TO: Sydney Central City Planning Panel

SUBJECT: 2 Bachell Avenue LIDCOMBE

APPLICATION No: DA2023/0775 / PPSSCC-550

SUMMARY

Figure - Height Plane

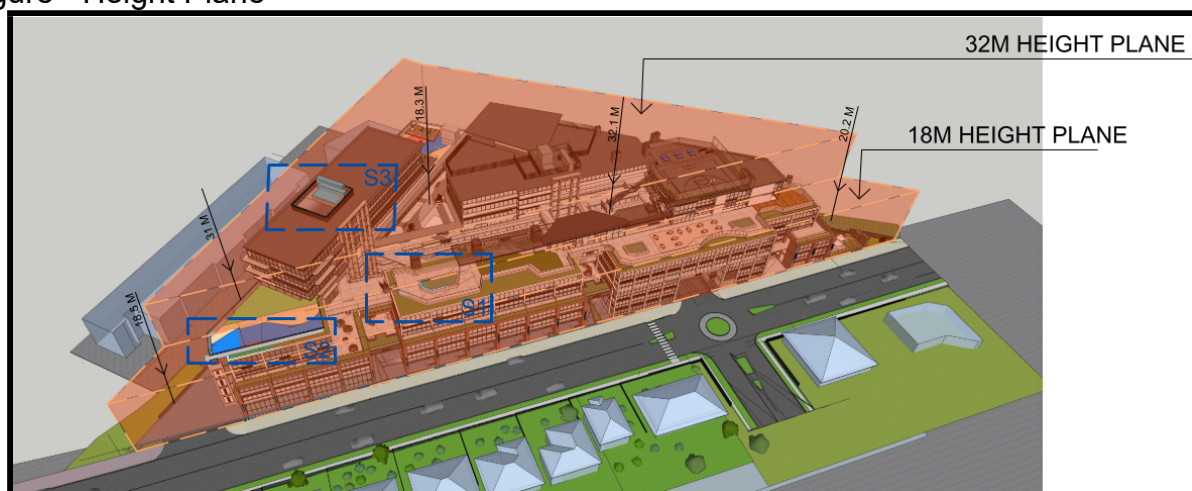
Breach location	Maximum height breach	% Variation
S1	1050mm	5.8%
S2	1900mm	10.55%
S3	1080mm	3.38%

- The three-storey street wall and stepped back from the street for the upper levels provides for an appropriate separation from the residential properties and public domain.
- There are no adverse shadowing or privacy issues being created.
- There is no habitable floor space that will breach the height of building plane.

- The highest breach being the lift overrun is setback over 30 metres from the front boundary and therefore its visibility from the street will be minimal.
- The proposal will not impact on any view corridors.

Additional areas included in Council’s GFA calculation.

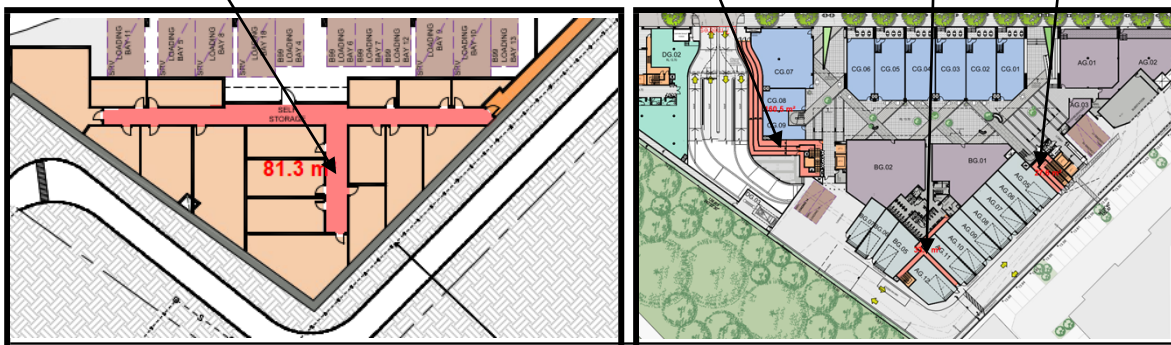
- It has not been demonstrated to the satisfaction of Council's Senior Development Engineer that the development can accommodate the additional GFA as there is insufficient onsite car parking to service the development.
- The Clause 4.6 is factually incorrect as it states there is no breach of the 32m height control, whereas the proposal in part breaches the height within the 32 metre height zone.

- Council’s calculation of the proposed FSR is 3.27:1 or 28,575.1 square metres which is a variation of 9%. Applicant states a FSR of 3.24:1 or 28,272square metres. This discrepancy comes from additional areas included in Council’s calculation which includes the corridors leading into the self-storage units and the horizontal fire exits on the ground floor (refer to figures below).
